UNITED STATES PATENT AND TRADEMARK OFFICE

APPLICATION NO.	FILING DATE	FIRST NAMED INVENTOR	ATTORNEY DOCKET NO.	CONFIRMATION NO.
10/560,397	04/11/2006	Takefumi Nishimuta	5000-5295	2526

Office Action Summary

DETAILED ACTION

Fig 1

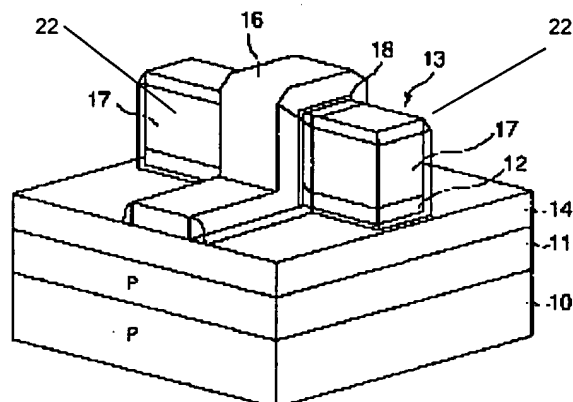
3. As to claims 1 and 6, Hieda discloses and shows (Fig 1) a MIS Field-effect transistor in which a projecting portion (17) is formed by a silicon substrate (10) having a first crystal surface (13) as a primary surface and a second crystal surface (17) as a side surface, a gate insulating film (18) is formed on at least part of the top surface and the side surface of the projecting portion, a gate (16) is formed on the gate insulating film, and a drain and a source (22) are formed on both sides enclosing the gate insulating film of the projecting portion.

12. As to claim 2, Hieda discloses and shows (Fig 1) that a channel (22) is formed on a first crystal surface of a top surface (13) and a second crystal surface (17) of the projecting portion and the channel width of the MIS field-effect transistor is a total of a channel width of the top surface and a channel width of the side surface (Hieda, paragraph [0016]).

Fig 2

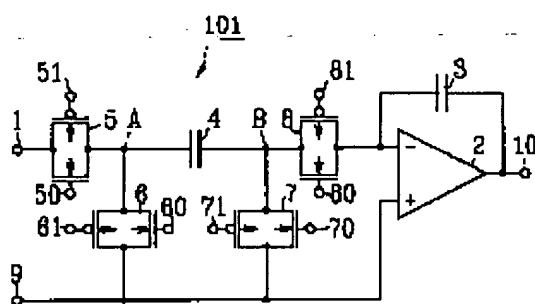
9. Mitsuru shows (Mitsuru, Fig 2) a switched capacitor circuit (101) including a capacitor (4) and a p-channel MIS field-effect transistor or an n-channel MIS field-effect transistor.

17. Mitsuru shows (Mitsuru, Fig 2) a switched capacitor circuit comprising a switch formed by connecting in parallel a p-channel MIS field-effect transistor and n-channel field-effect transistor.

20. As to claim 5, Hieda as modified by Mitsuru shows (Mitsuru, Fig 2) the switched capacitor circuit comprises: first p-channel and n-channel MIS field effect transistors (Mitsuru, 50,51) which receive a signal at an input terminal (1), and are connected in parallel to each other; second p-channel and n-channel MIS transistors (Mitsuru, 60,61) which are connected to each other, whose input terminals are connected to output terminals of the first p-channel and n- channel MIS field-effect transistor, and whose output terminals are grounded; a capacitor (Mitsuru, 4) one terminal of which is connected to an output terminal of the first p-channel and n-channel MIS field-effect transistors; third p-channel and n-channel MIS field-effect transistors (Mitsuru, 70,71) which are connected in parallel to each other, whose input terminal is connected to another terminal of the capacitor, and whose output terminal is grounded; and fourth p-channel and n-channel MIS field-effect transistors (Mitsuru, 80,81) which are connected in parallel to each other and whose input terminal is connected to another terminal of the capacitor.

Fig 3

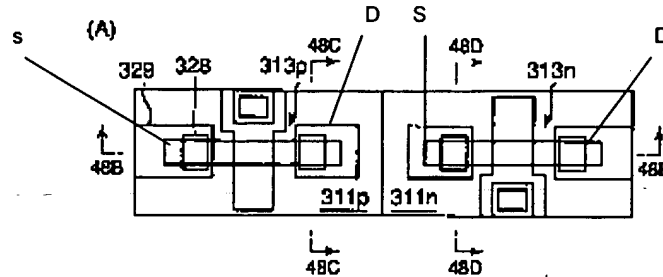
13. As to claim 3, Hieda discloses and shows (Fig 1 and 2) the projecting portion has a top surface comprising a silicon surface (100) (Paragraph [0036]), and the source (S) and drain (D) are formed on the projecting portion enclosing the gate and in left and right area of the projecting portion of the silicon substrate (Fig 3).
